PRINCE OF WALES DR. DEVELOPMENT

Railway Proximity
Assessment Review

SYSTRA Canada Reference: 24619-10-GETN-0001_A

| <input type="checkbox"/> Preliminary/internal verification | <input type="checkbox"/> Submitted for information | <input checked="" type="checkbox"/> Issued for revision and comments |

Figure 3-2: FCM/RAC's Standard Noise Mitigation Measure

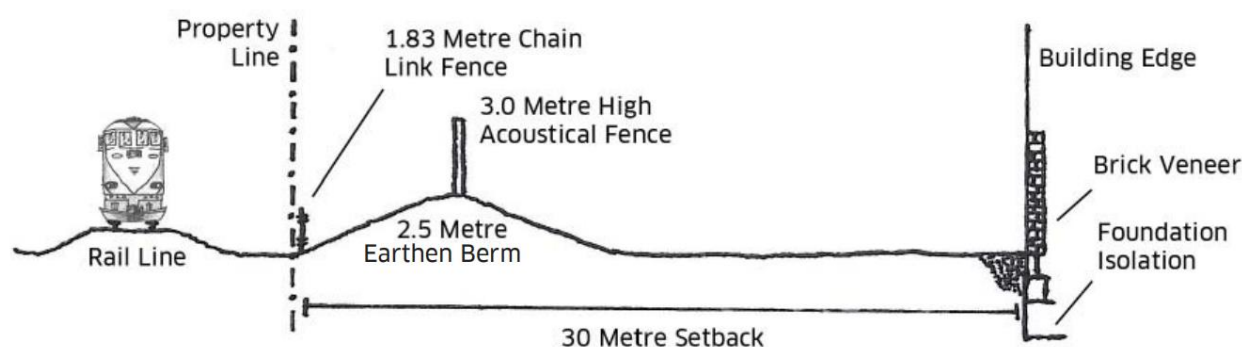
For a standard noise mitigation, FCM/RAC's Guidelines for New Development in Proximity to Railway Operations recommends a 3-m-high acoustical fence installed on a 2.5-m-tall earthen berm for building having 30-metre set-back from the right-of-way (ROW) line.

Generally, noise barriers provide significant noise reductions only when they block the line of sight between the noise source and the receiver.

Figure 3-5: Receptor's Line of Sight

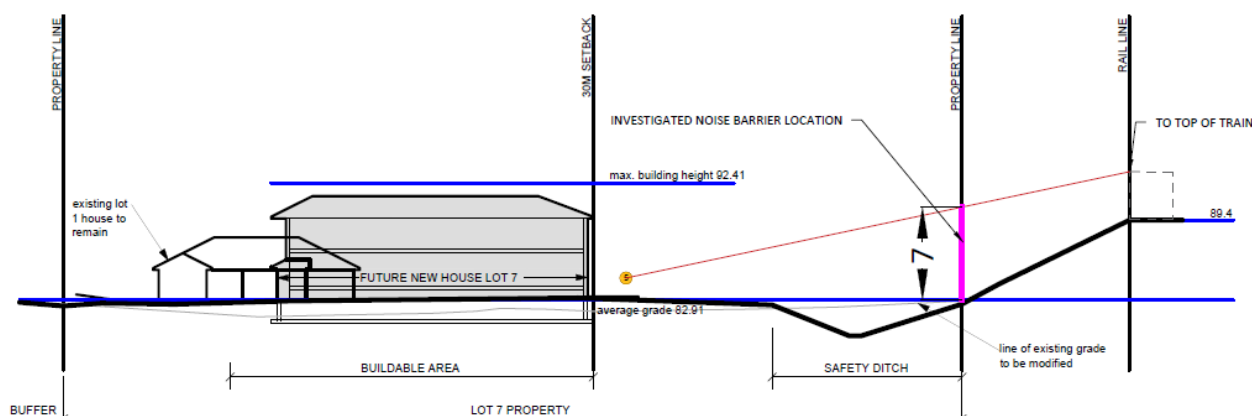
Since the railway track is approximately 6.5 m above the study site's average grade, it was determined by the Transportation Noise and Vibration Assessment that the implementation of a noise barrier is not considered technically, economically, and administratively feasible for the lots backing onto the VIA Rail corridor, and a Warning Clause will be required in all Lease, Purchase and Sale Agreements.
